Service Bulletin

Subject: No Start/Stall - Seat Bottom Contacting Rear Electrical Center (REC)

Brand:	Model:	Model Year:		VIN:		Engine:	Transmission:
		from	to	from	to		
Buick	Lucerne	2008	2011			All	All
Cadillac	DTS	2008	2011

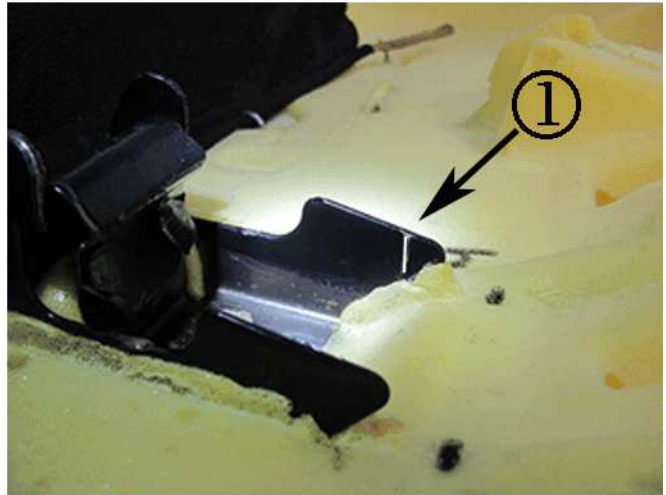
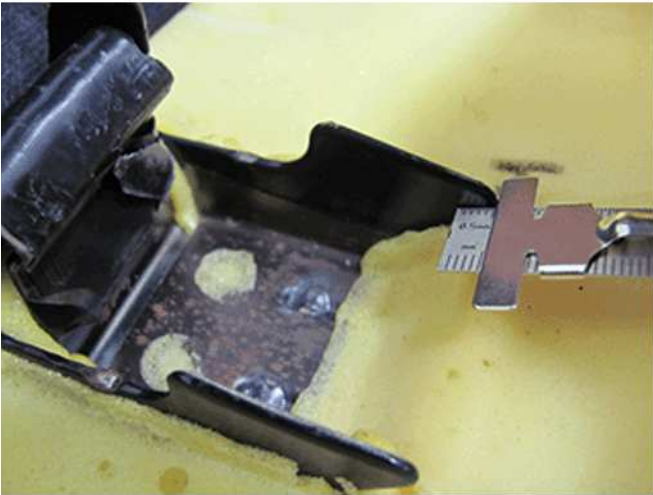
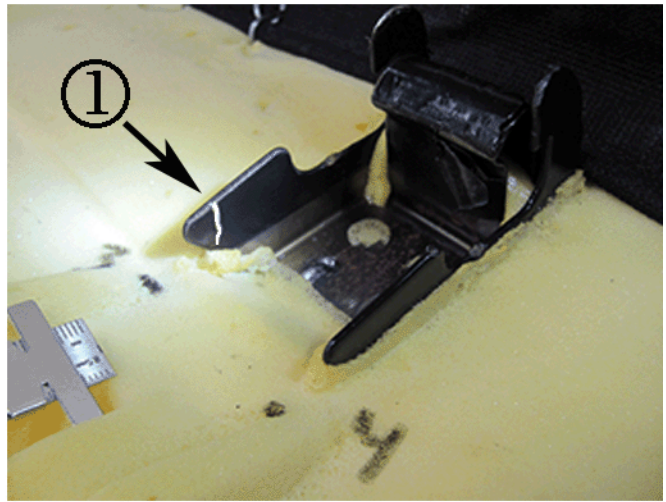
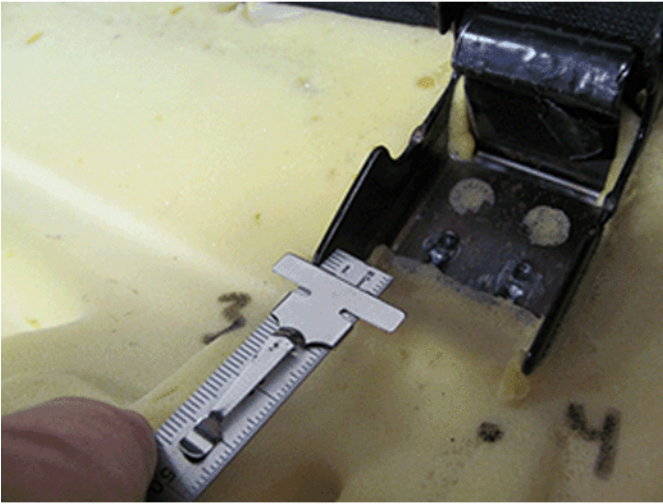
Involved Region or Country	North America and N.A. Export Regions
Condition	Some customers may comment on a no-start or stalling.
Cause	The rear seat bottom may come into contact with the rear electrical center (REC) cover. The contact/interface results in varying amounts of deflection of the fuel pump relay (FPR). The movement of the FPR causes potential wear of the male terminals on the FPR.

- Install a low profile fuel pump relay (DTS and Lucerne).
- Remove material from the rear seat bottom frame, driver side mounting brackets (Lucerne Only).

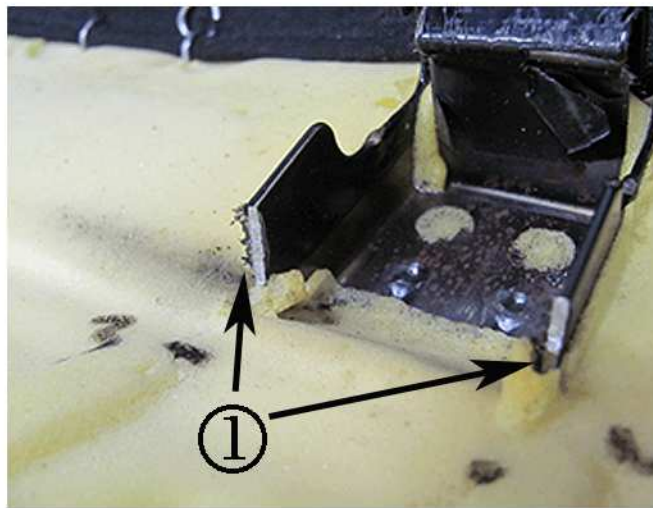
6. For Lucerne only, with the rear seat cushion on a bench, measure 5 mm (0.197 in) from each edge of the right side seat mount bracket and mark with a paint marker as shown (1).

7. For Lucerne only, using a cut off wheel or equivalent, carefully cut each side of the bracket as shown (1). Check for any rough edges and file if necessary.
8. Install the rear seat cushion and close door.
